The Timberyards by RTL Co. SSDA RTS Comments

Prepared for RTL.co
May 2025

Rev A Issued May 2025

Masterplan
Landscape

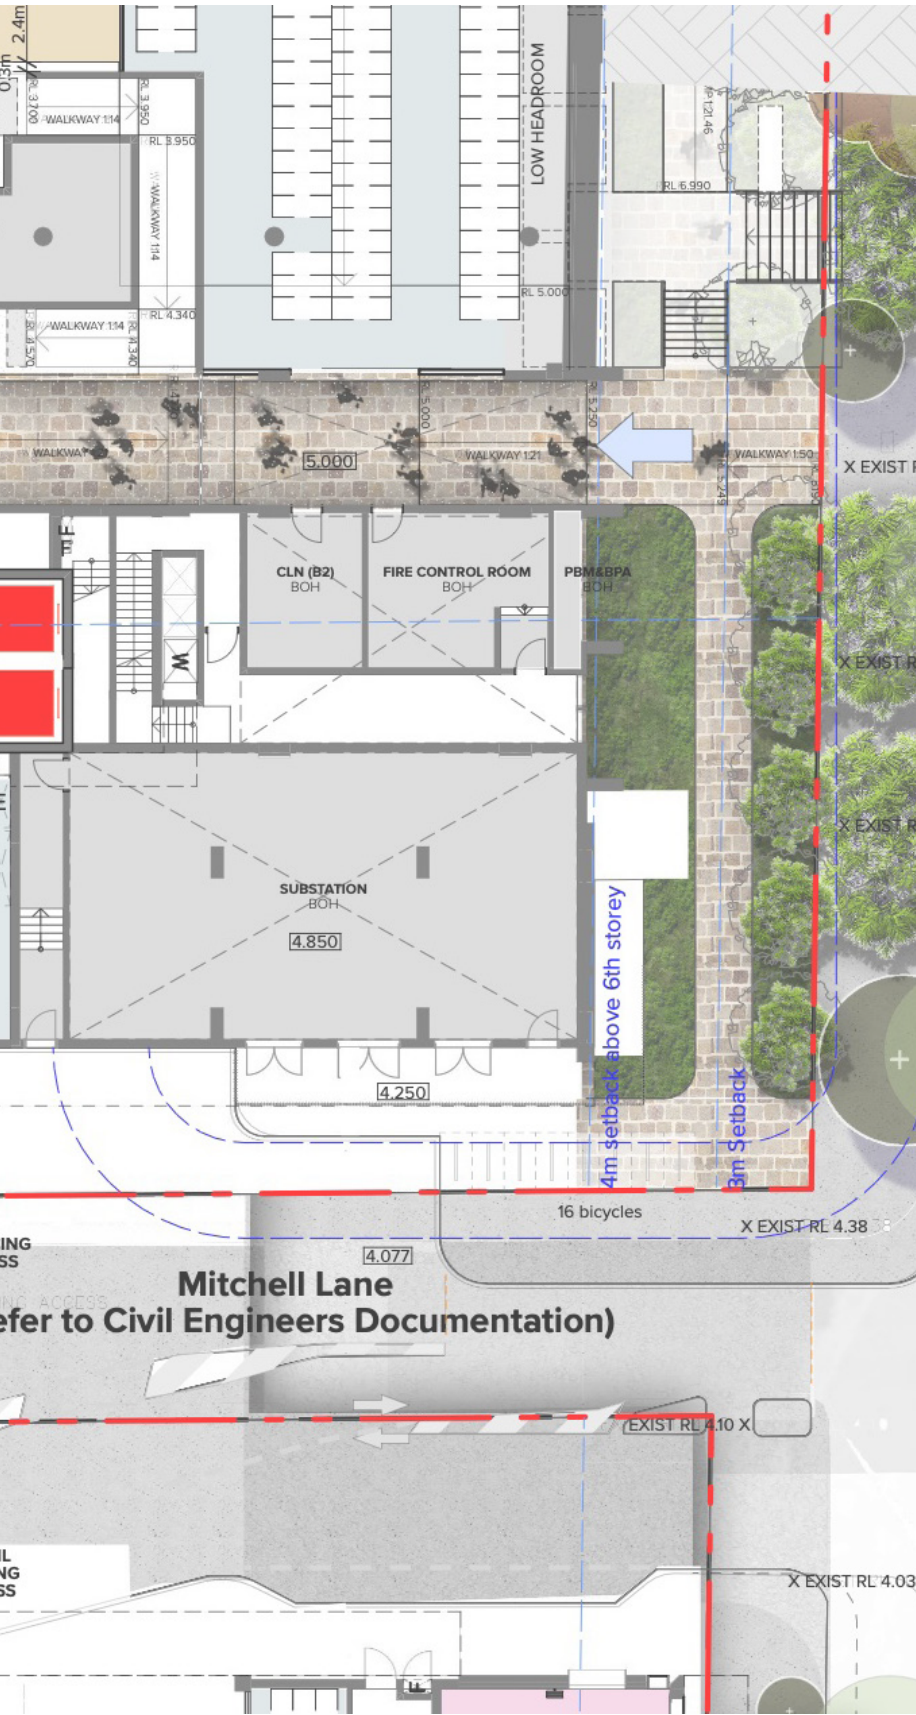
IWC 4. Public Domain Works

(d)
The proposal indicates a new footpath along Mitchell Street within the front setback of the site. The footpath is to be for public use, and shall ensure that the footpath, landscape and movement is coordinated with the pocket park approved under

ASP3 Designer DEP Consulting Pty Ltd has reviewed the interface and integration of landscape setbacks and Ausgrid access requirements and confirms there are no issues. Ongoing design coordination will continue to ensure Ausgrid requirements are satisfied.

Landscape Zones
Farr St Pocket Park Plan

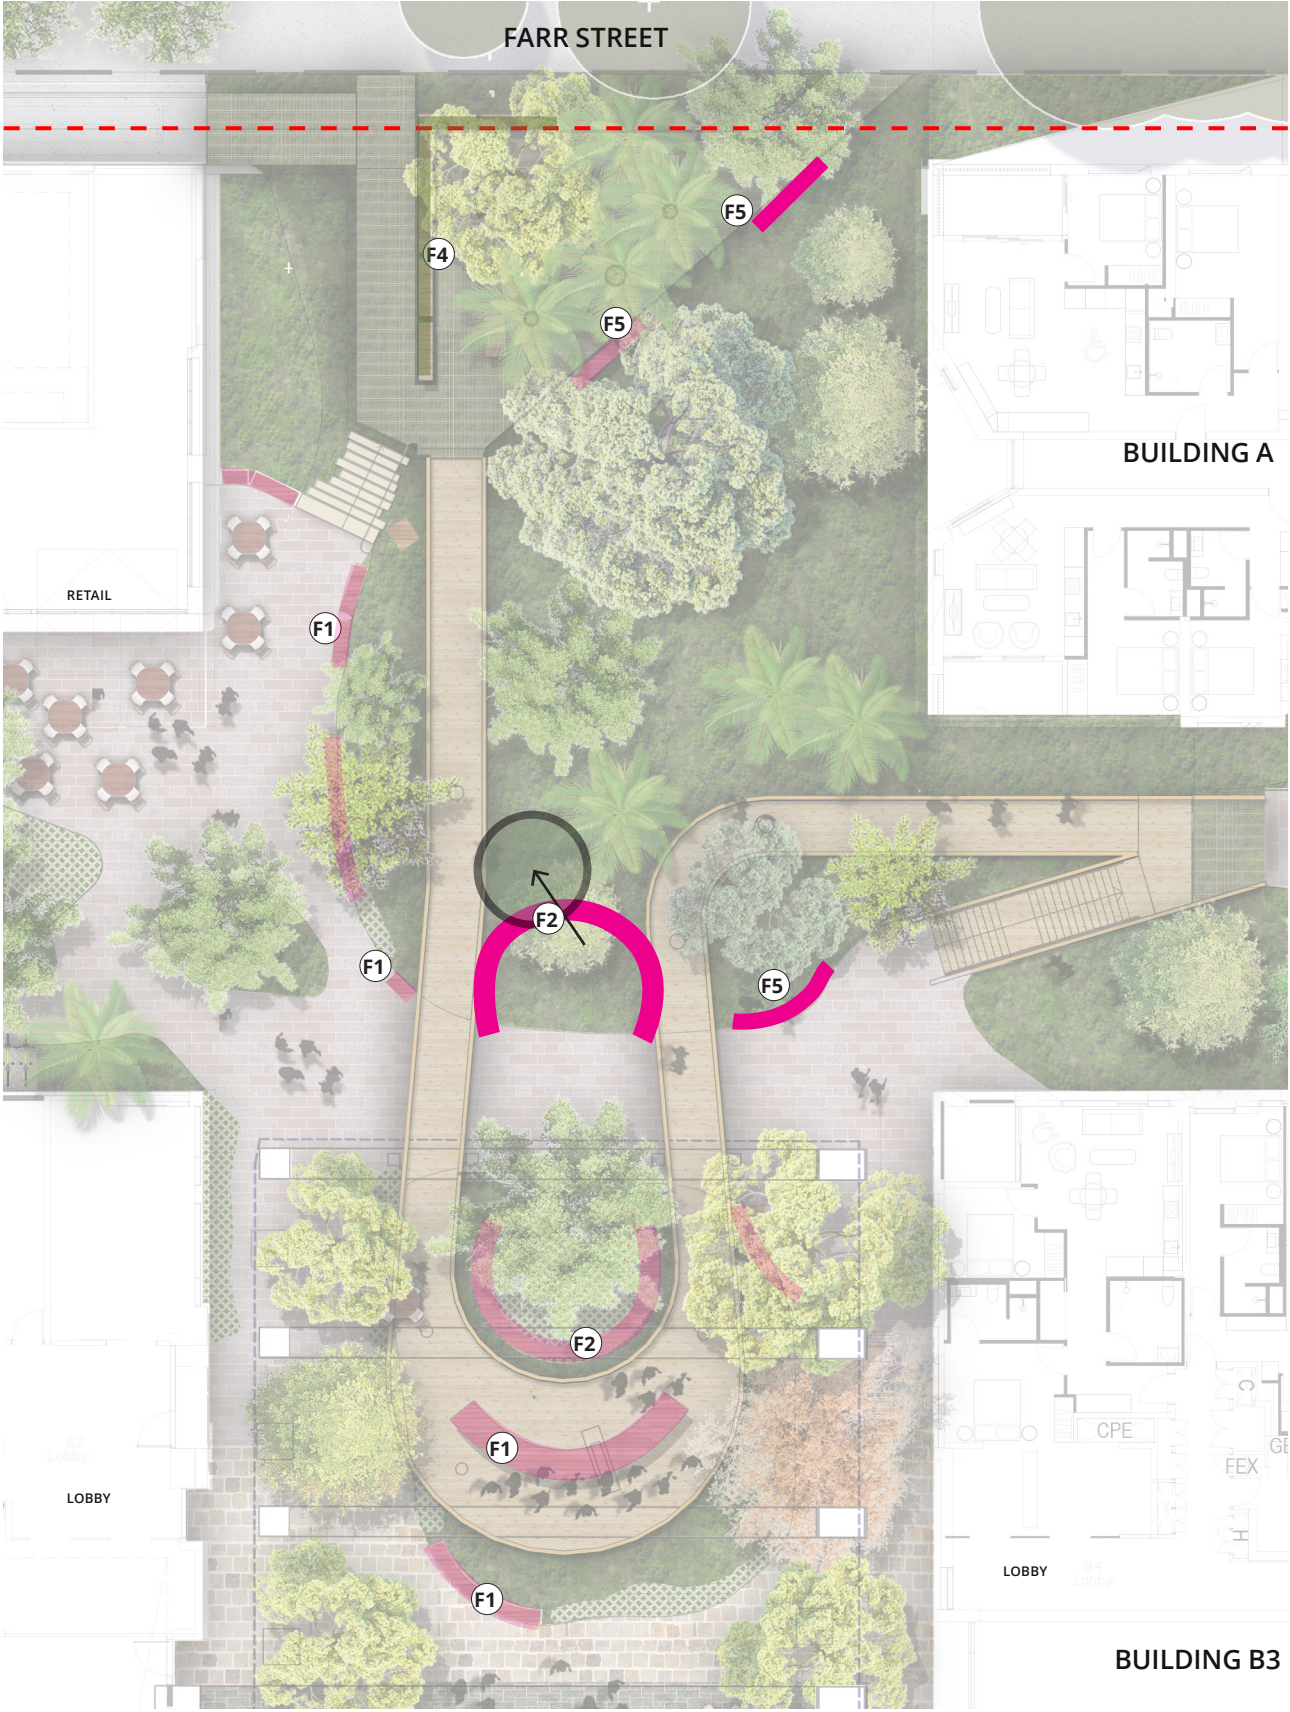
DPHI - 27
Review public seating provisions and identify ways to increase seating within the proposed pocket park.

We have looked at all opportunities for additional seating and have identified 3 more locations:

- F2 x 1
- F5 x 2

The tree under the new F2 is to be relocated.

PLAYGROUND AREA 01

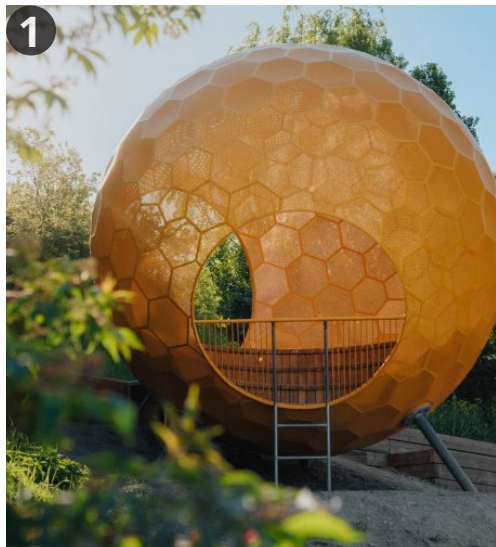
Review proposed playground and provide details on location and proposed equipment.

The response has be broken into two playground areas which are designed for different age groups (Older and Younger). The design considers the entire comons area as a playful landscape but has highlights these two areas. The theme is very intergrated, interpretive and natural.

PLAYGROUND AREA 01 - PLAY STRUCTURE

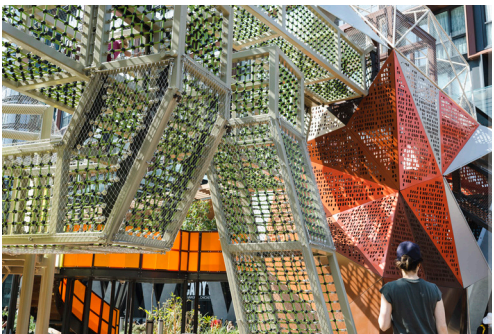
Review proposed playground and provide details on location and proposed equipment.

Central Play Element

PLAYGROUND AREA 02
RESPONSE

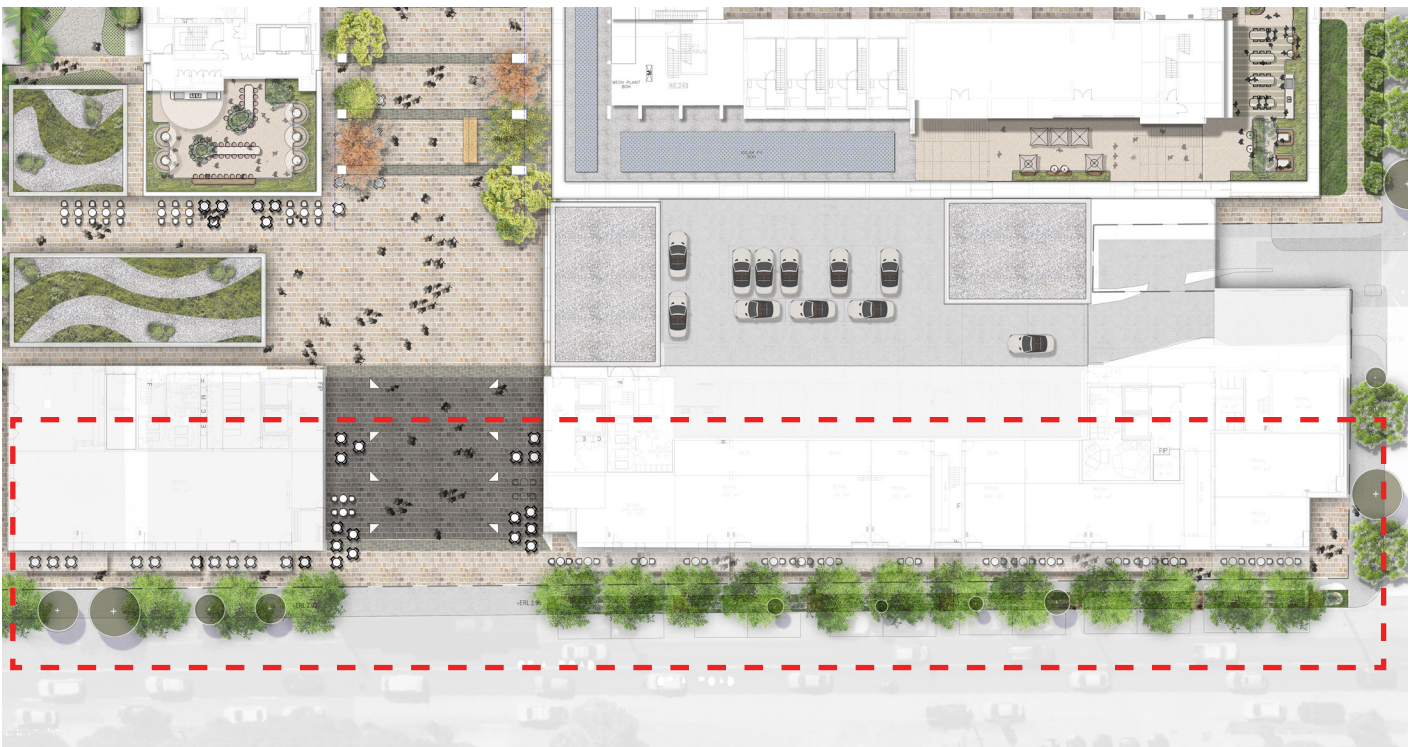
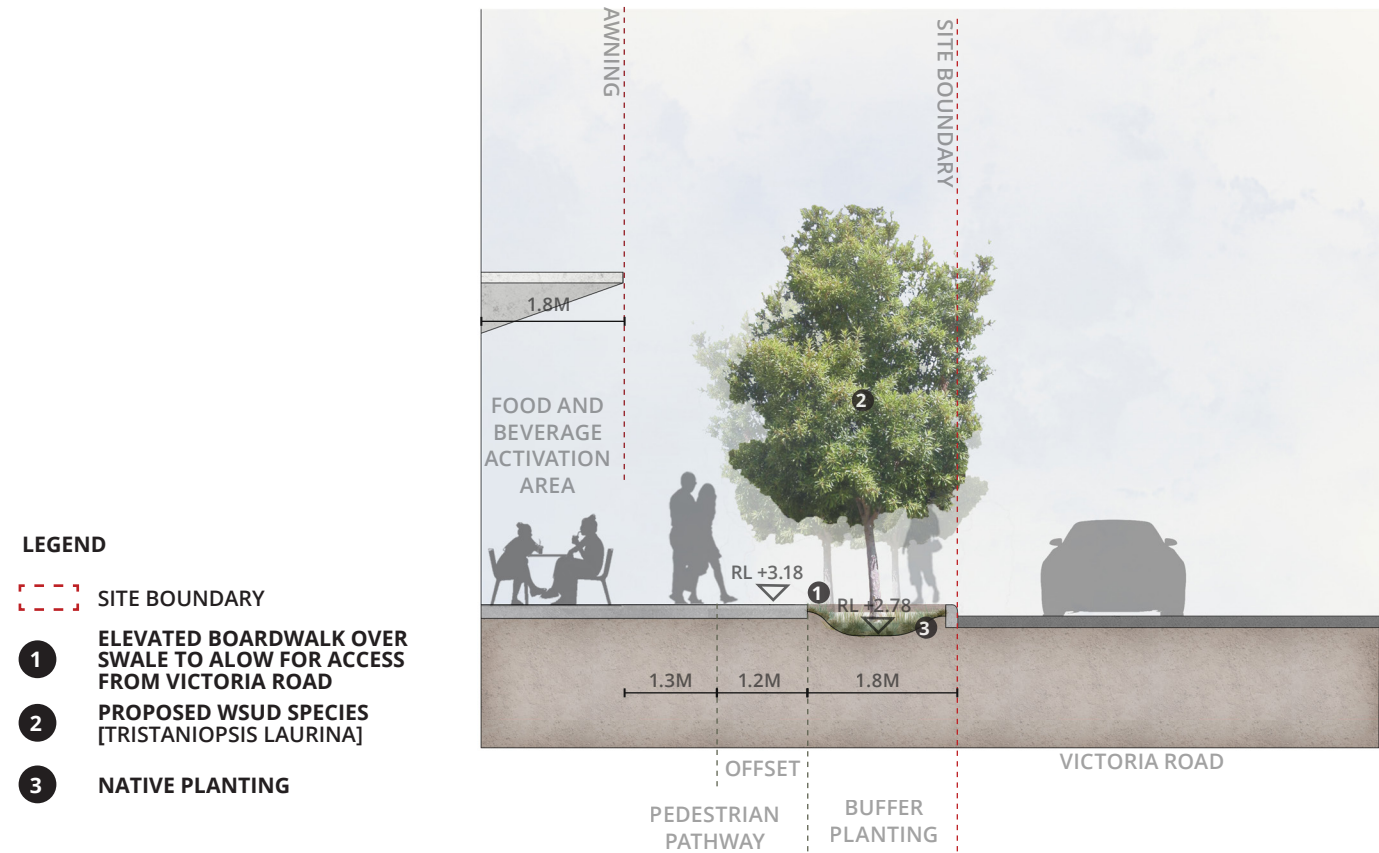
Review proposed playground and provide details on location and proposed equipment.

The response has be broken into two playground areas which are designed for different age groups (Older and Younger). The design considers the entire comons area as a playful landscape but has highlights these two areas. The theme is very intergrated, interperitive and natural.

Masterplan Landscape

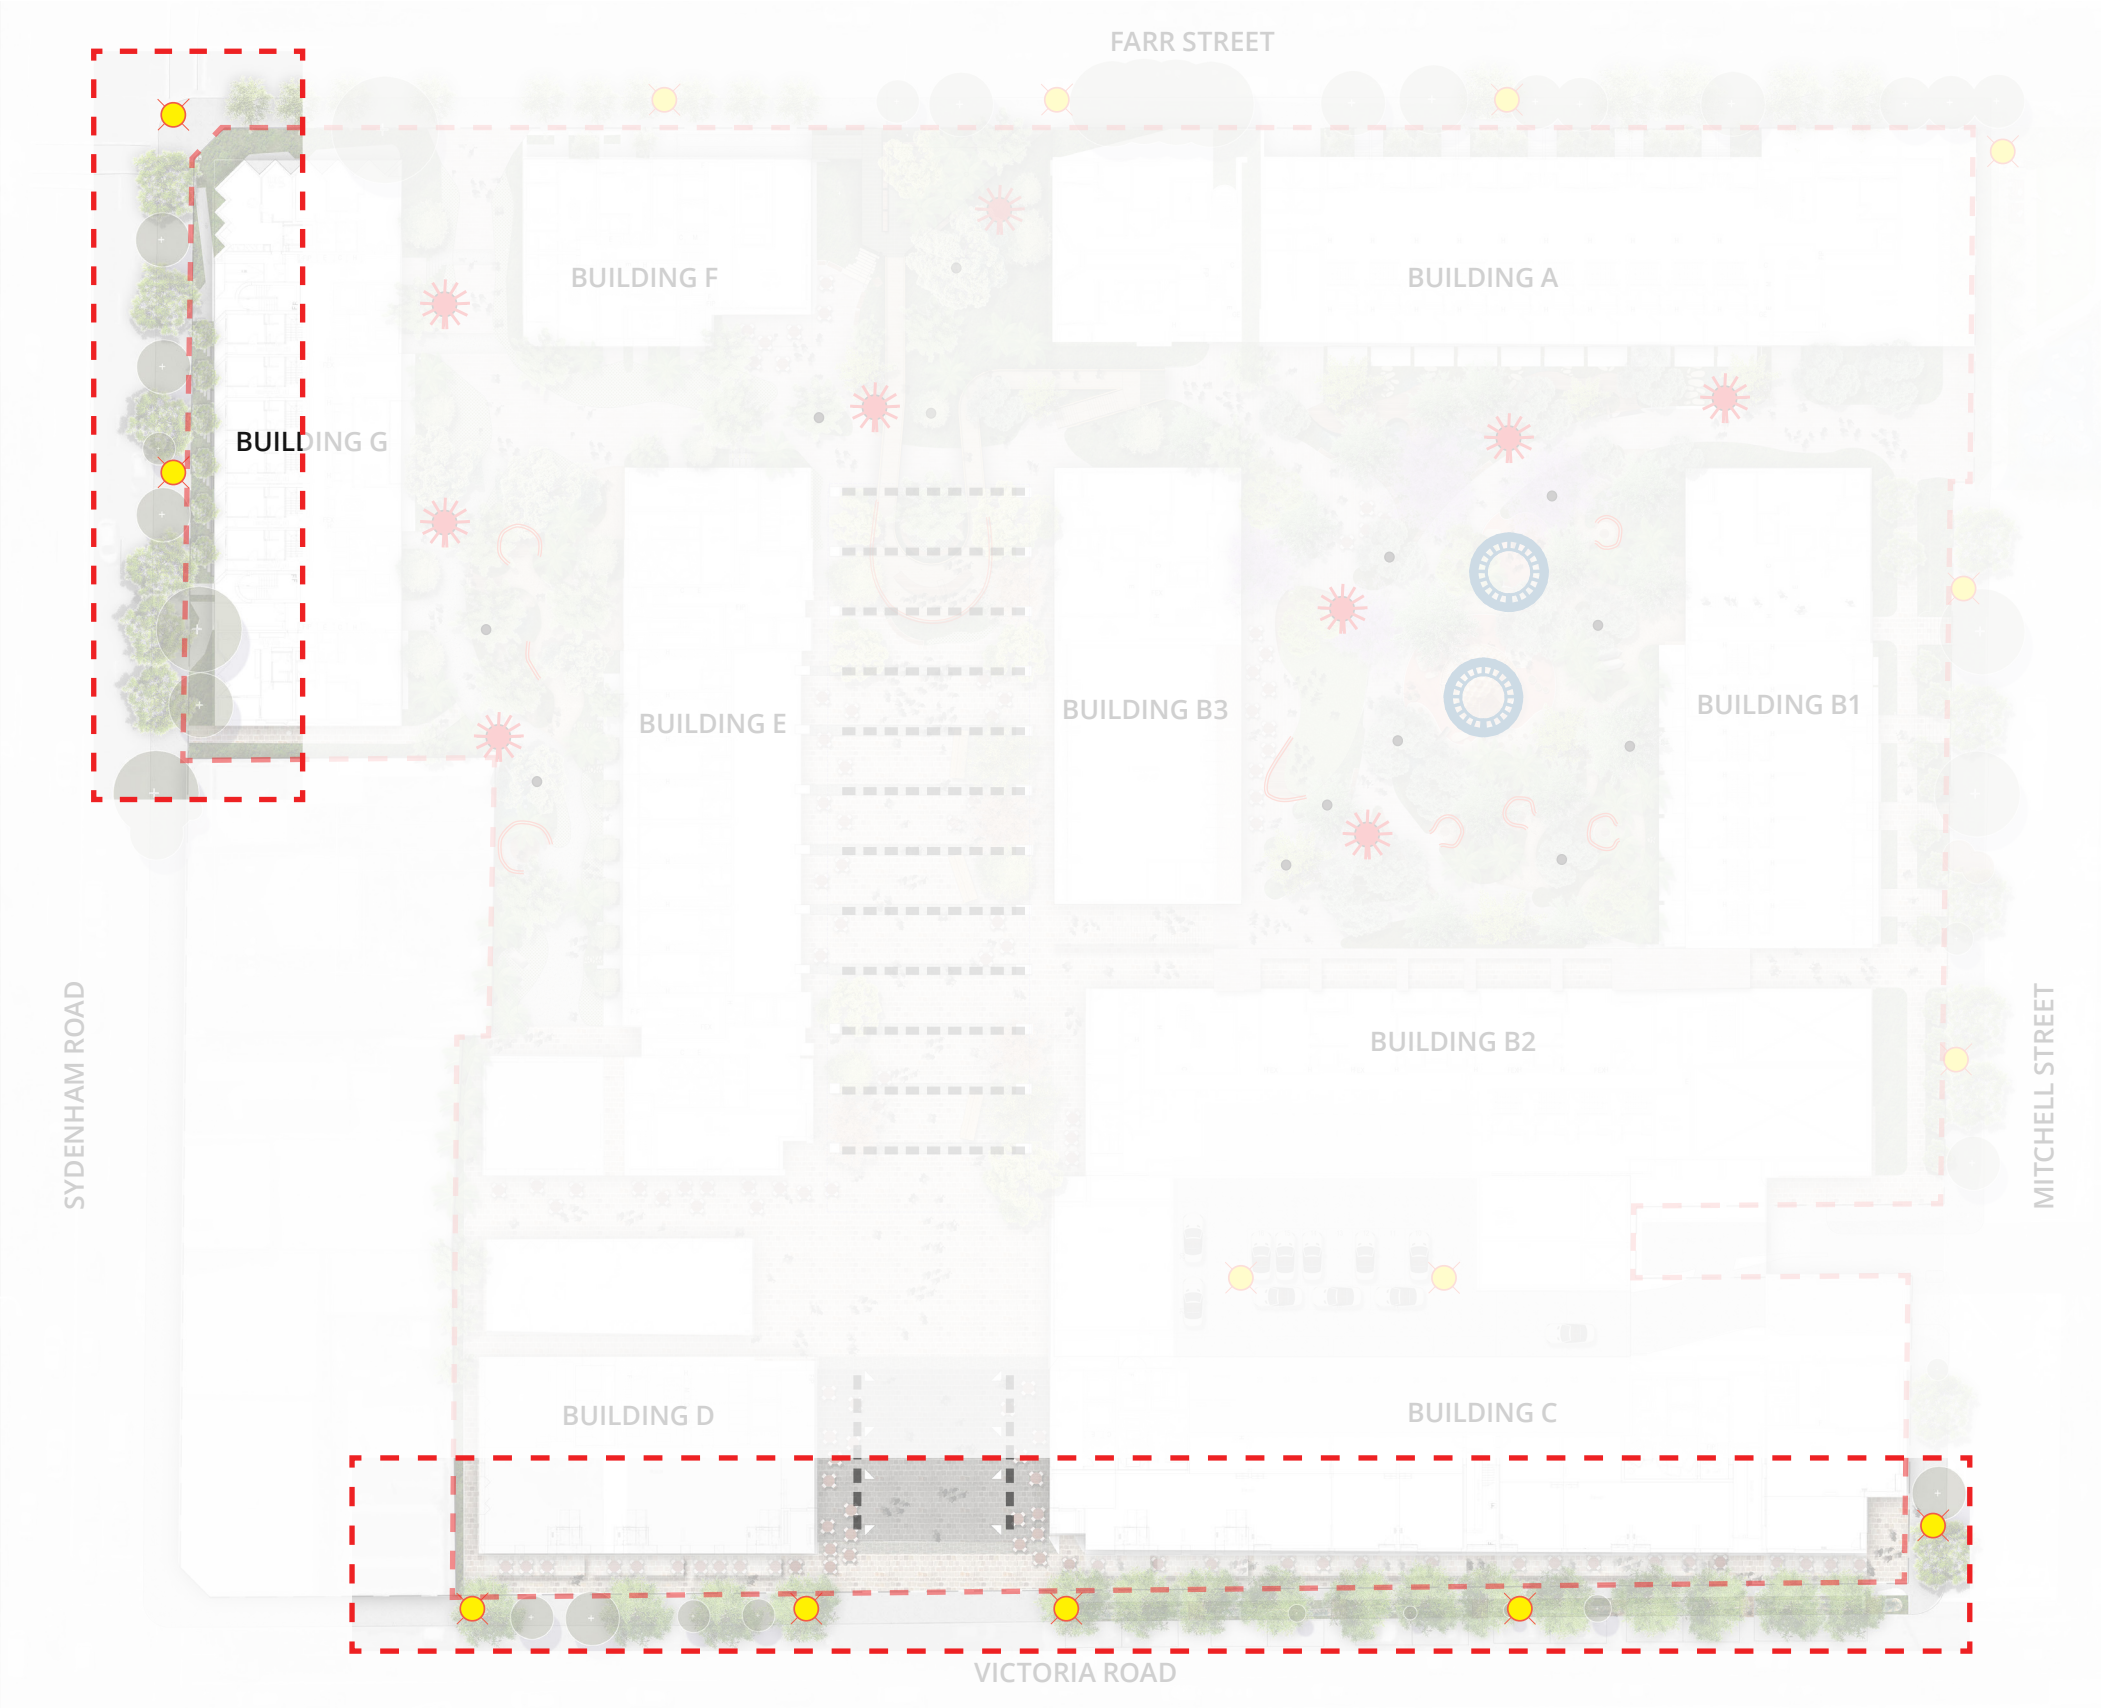
A) Review plans to demonstrate the provisions of multi-function pole lighting on Victoria Road, Sydenham Road and Mitchell Street frontages.

A) If any electrical pillars are to be provided, review plans to demonstrate clearance from the road reserve and 1.5m footpath Activation Zone.

The diagram on the right is indicative but illustrates multi-function pole lighting on Victoria Road, Sydenham Road and Mitchell Street frontages.

Refer the Lighting/Electrical Design for further details including electrical pillar locations.
